HOPE CREEK GENERATING STATION  
DOCKET NO. 50-354  
FSAR COMMITMENT STATUS THROUGH AUGUST 1984

ATTACHMENT I  
HOPE CREEK GENERATING STATION  
FSAR COMMITMENT STATUS THROUGH AUGUST 1984

QUESTION 220.21 (SECTION 3.7.2)

FIGURE 220.21-40  
 RESPONSE SPECTRA COMPARISON,  
 INTAKE STRUCTURE AT ELEV. 93' -0",  
 U.S. NUCLEAR REGULATORY COMMISSION

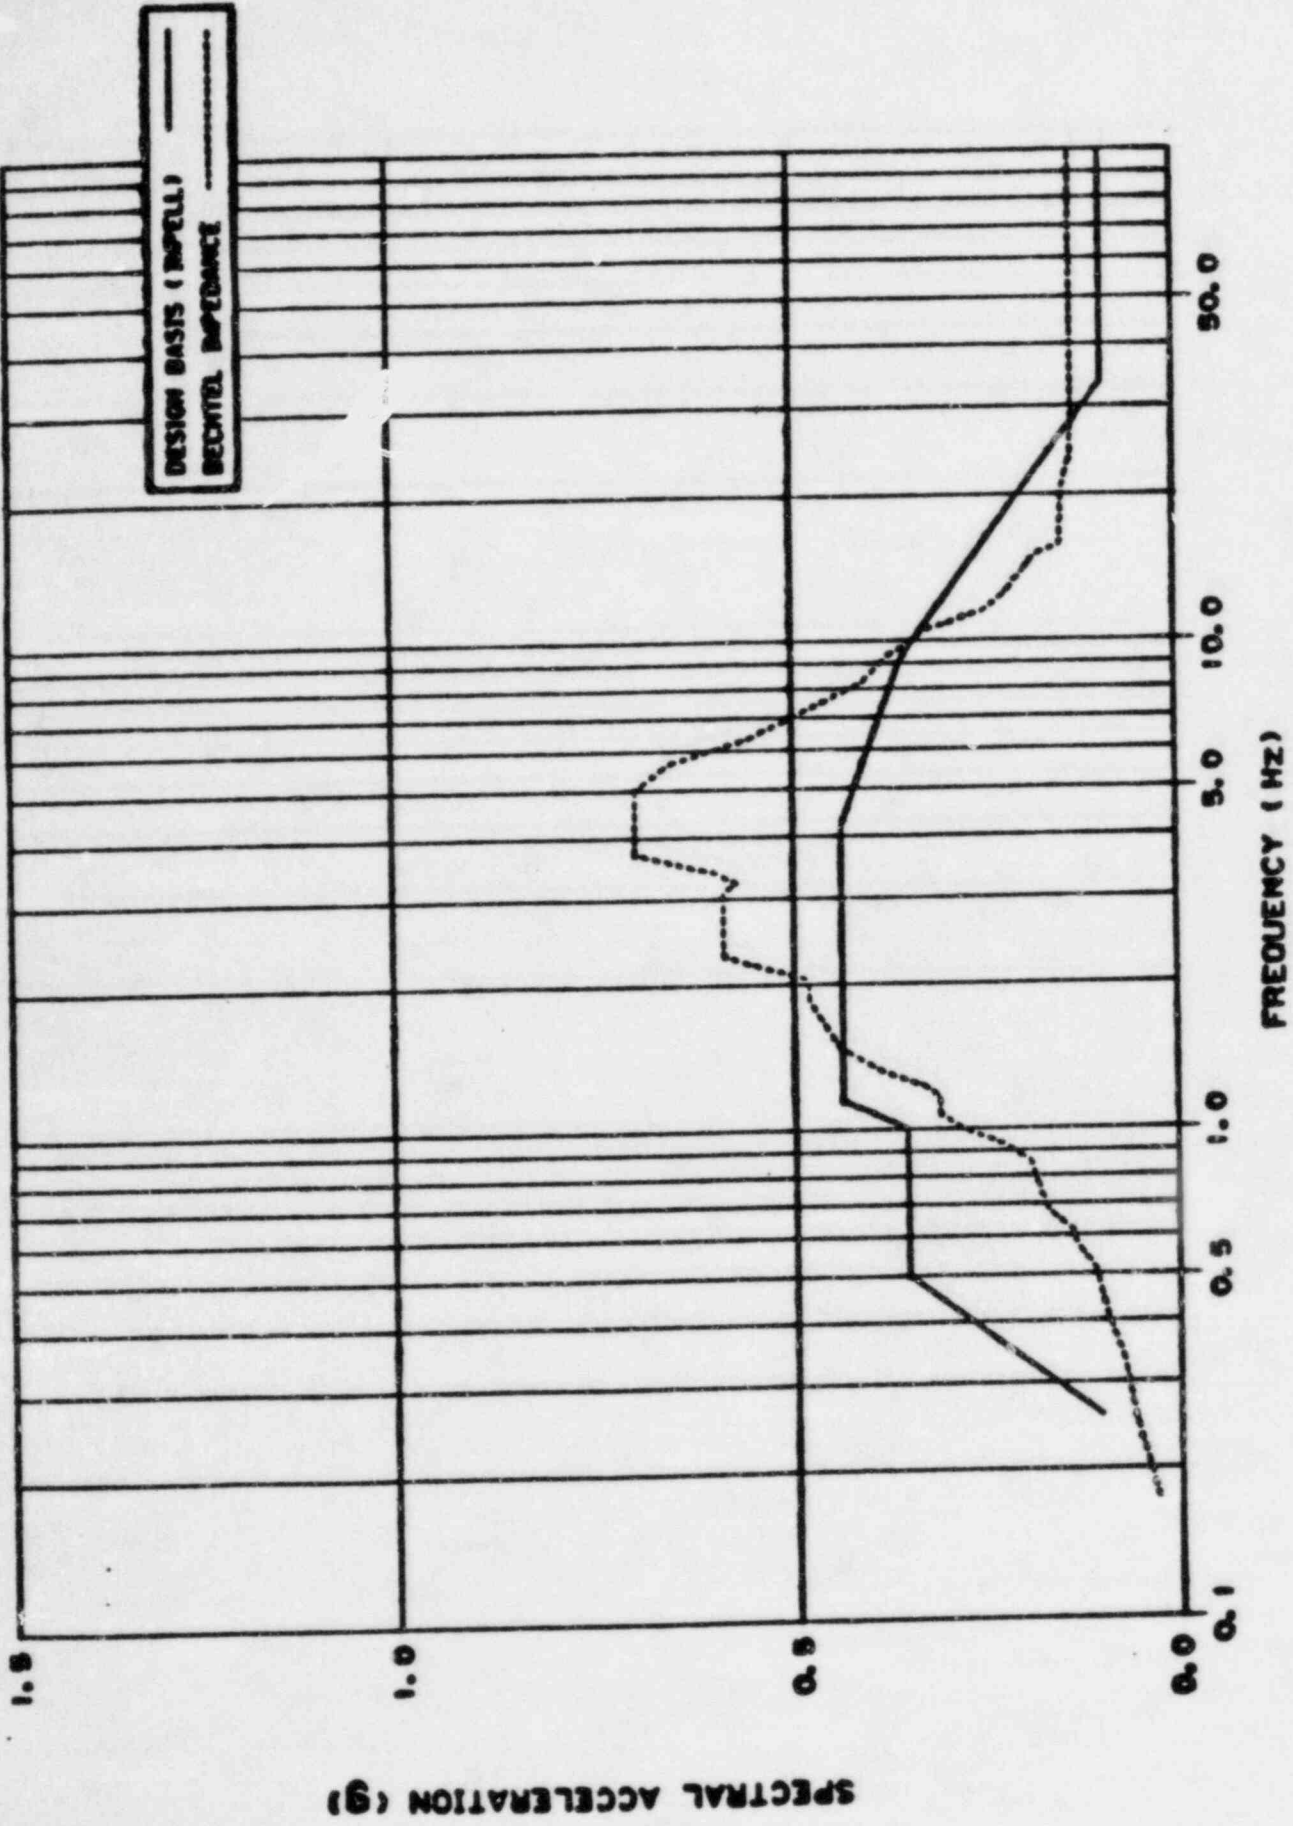
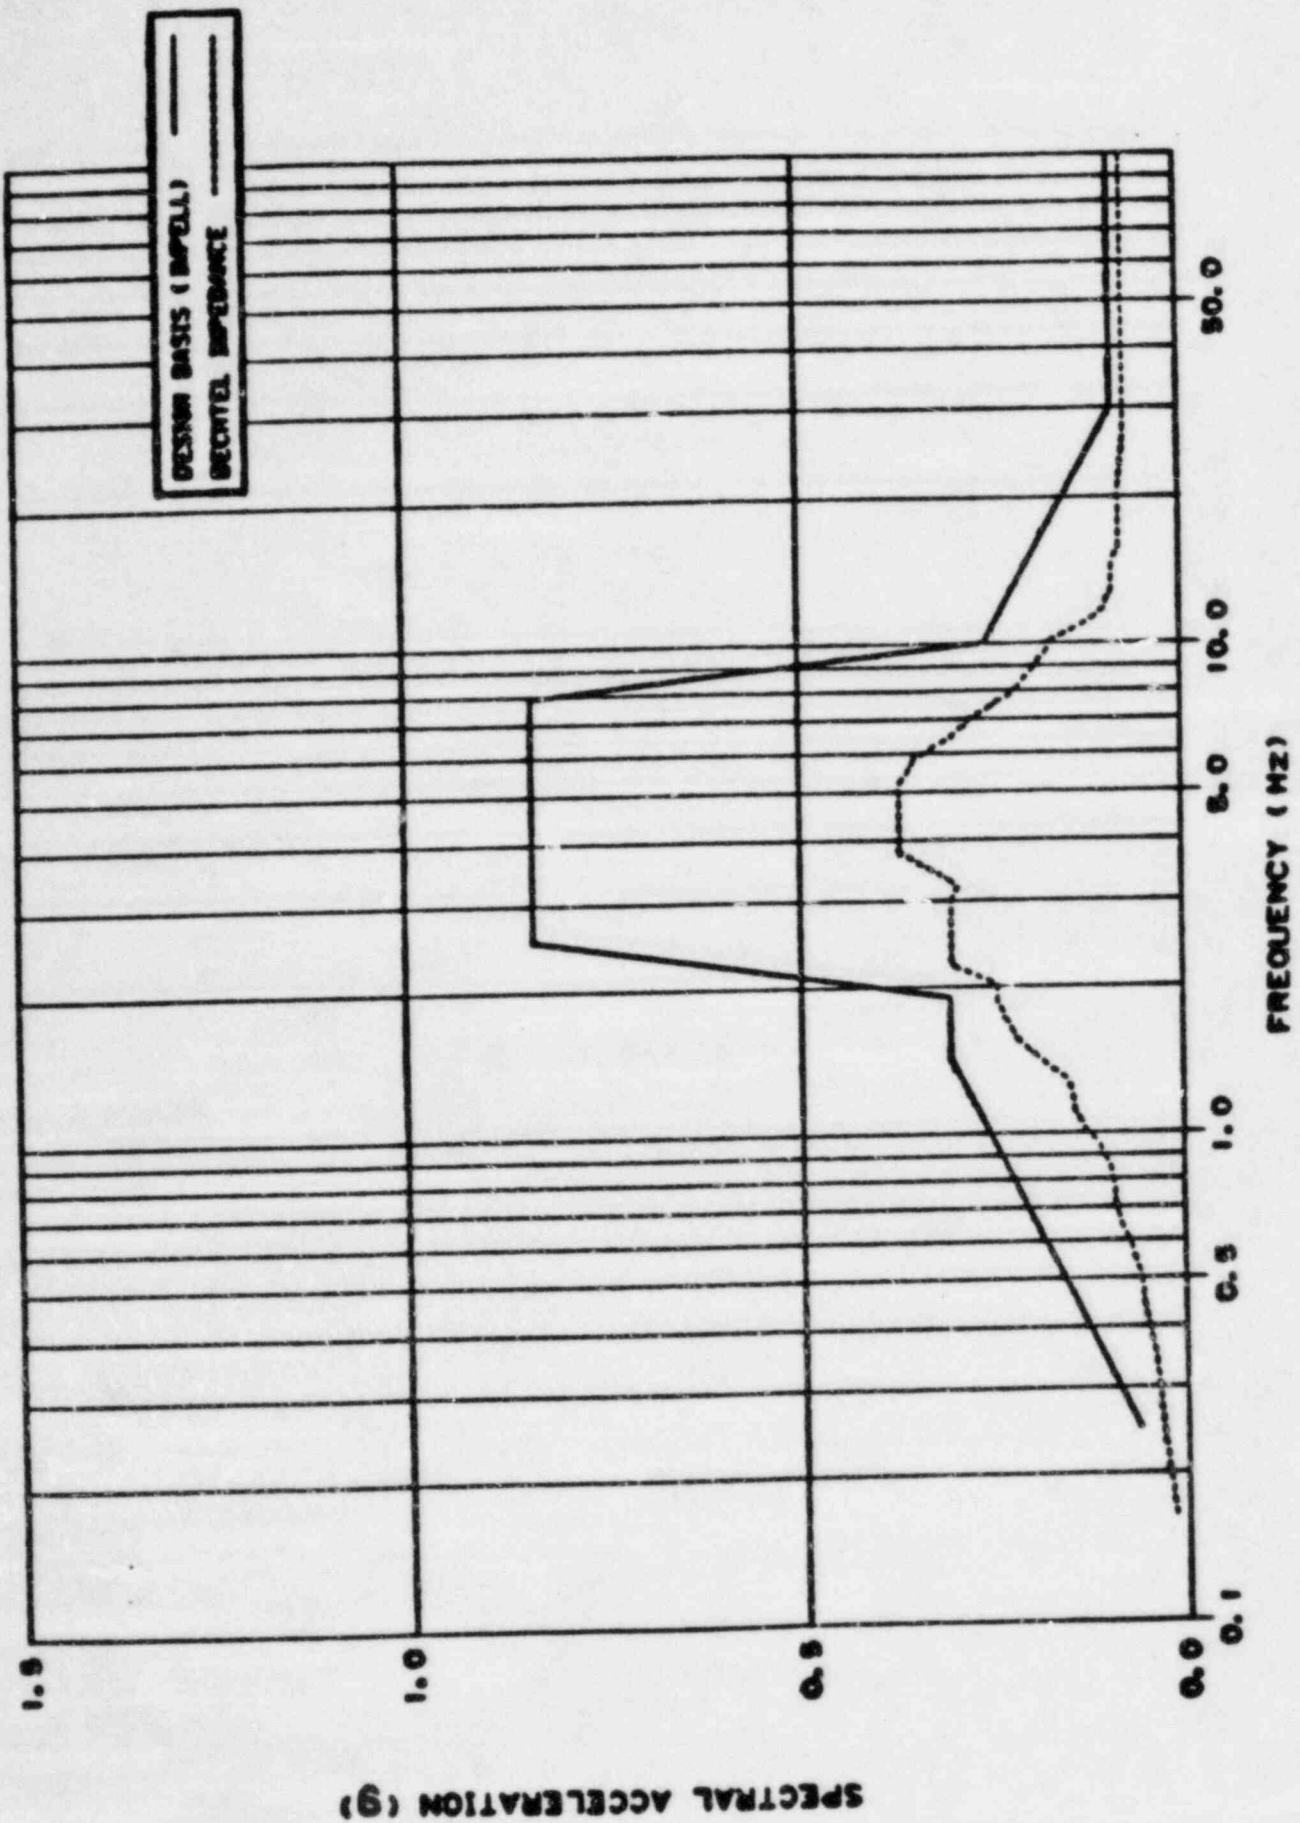
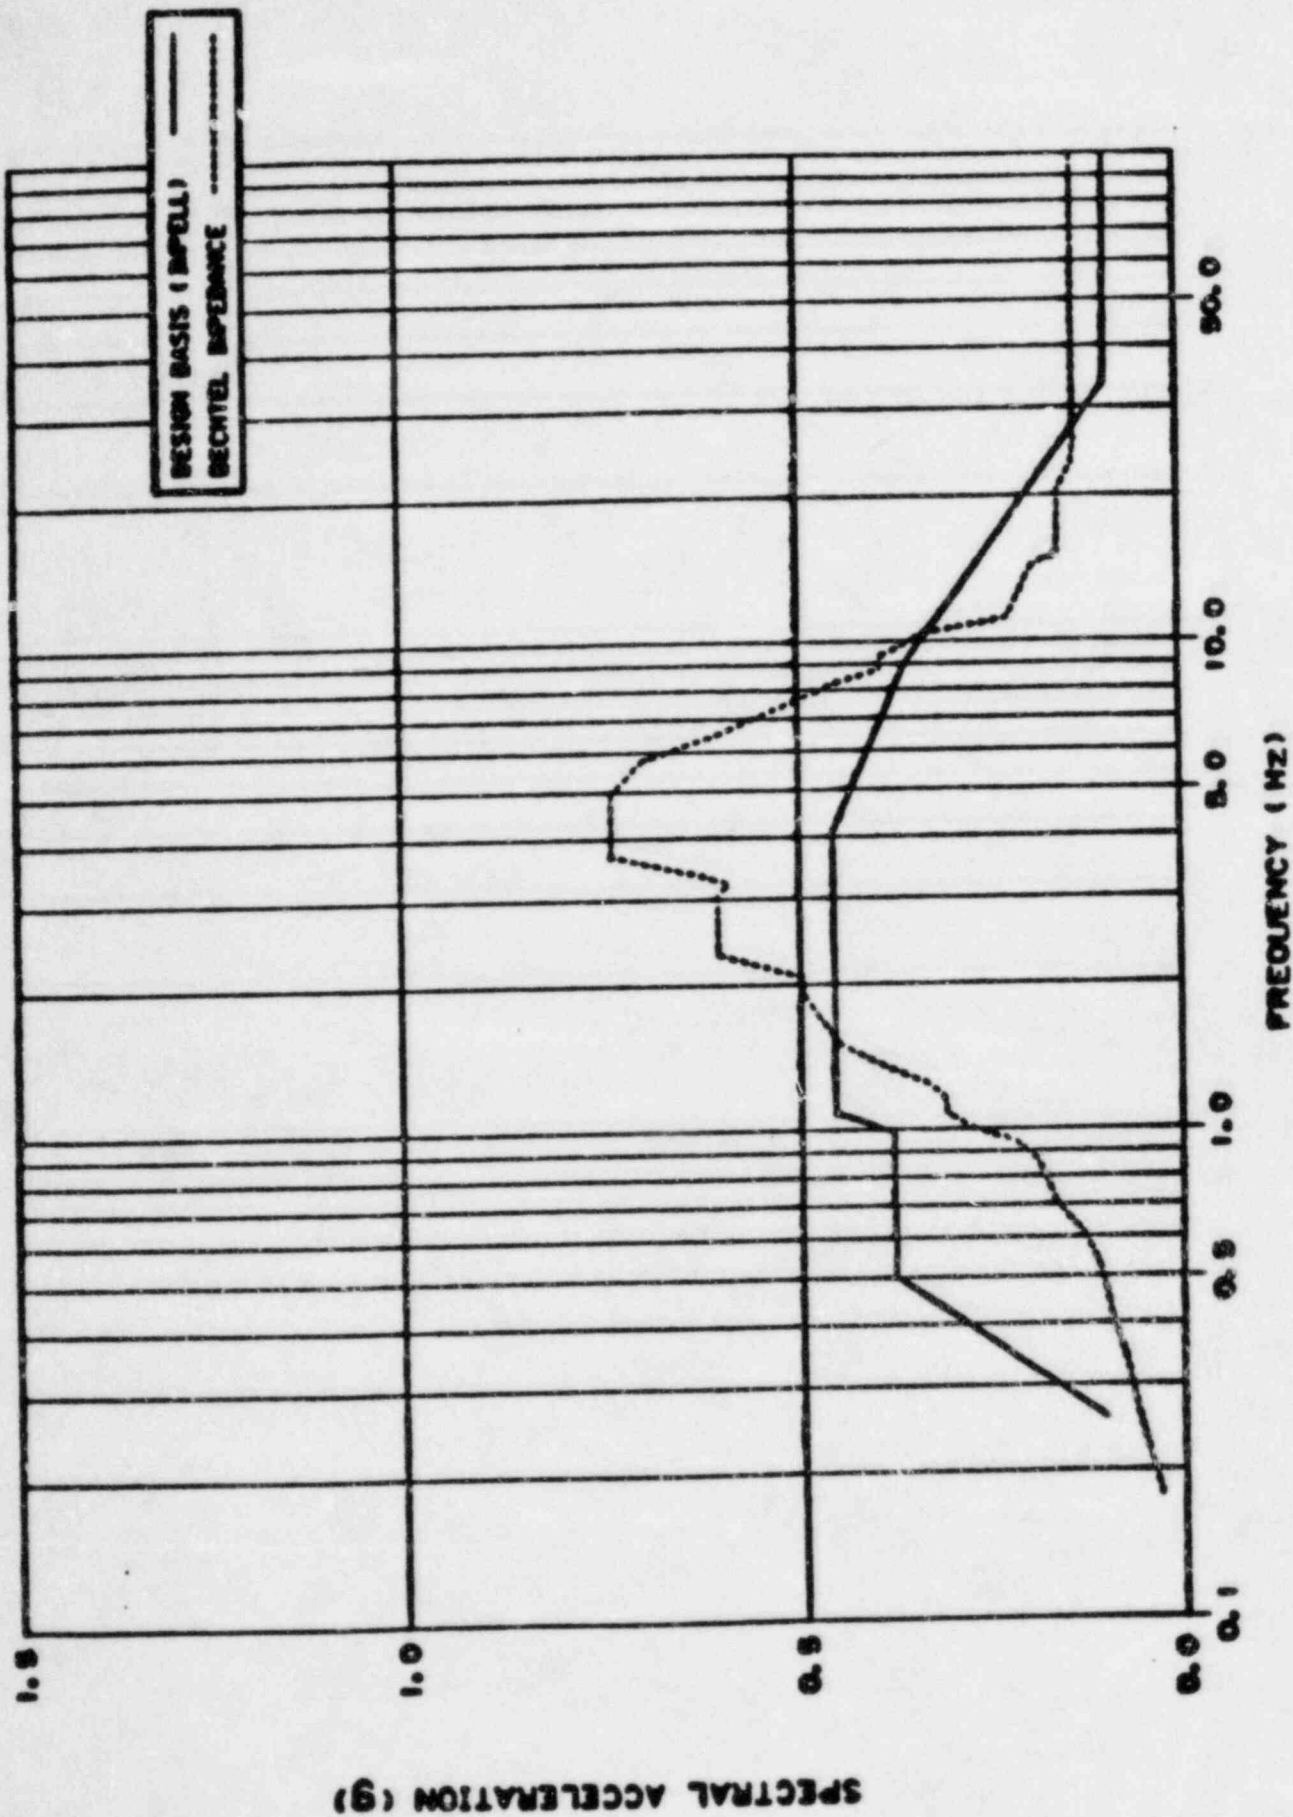
The Hope Creek soil-structure interaction analysis is performed by applying a specified earthquake input motion at the base of the finite-element model. The base level input motion is generated through a deconvolution analysis. The applicable SRP criteria for soil-structure interaction analysis require that both the half-space and finite-element approaches should be considered. (For details refer to SRP 3.7.2-11.4). Public Service should perform necessary analyses to demonstrate conformance to the criteria.

Figures 220.21-1 through 220.21-54 show a comparison of the 2 percent damping response spectra obtained from the design basis finite element and the impedance analyses for the reactor building, auxiliary building and the service water intake structure (SWIS).

¶ For the reactor and auxiliary buildings, the peak spectral accelerations obtained from the impedance analysis are generally lower than those obtained from the design basis analysis. However, the impedance analysis response spectra are not completely enveloped by those obtained from the design basis analysis, especially in the frequency range from 1.0 to 3.5 Hz. Also, there are some local exceedances in the higher frequency range, as shown in Figures 220.21-1 through 220.21-36. ¶ For the SWIS (Figures 220.21-37 through 220.21-54), the impedance analysis response spectra are generally enveloped by those obtained from the design basis analysis at elevation 114.0 feet. For other elevations, the impedance analysis spectral accelerations exceed the design basis spectral accelerations in some frequency ranges. These ranges vary approximately between 1.5 and 10.0 Hz.

forces and moments obtained from the impedance analysis exceeded the design basis values at various locations within these buildings. The auxiliary building seismic shear forces and moments obtained from the impedance analysis are less than the design basis shears and moments.

Since the impedance analysis results are not completely enveloped by the design basis finite element analysis results, sampling studies are conducted to confirm the adequacy of the plant design. These sampling studies include an evaluation of the following items:

In all cases, the items reviewed during these sampling studies can accommodate the loads resulting from the impedance analysis. Therefore, the impedance analysis results have no impact on the plant design.
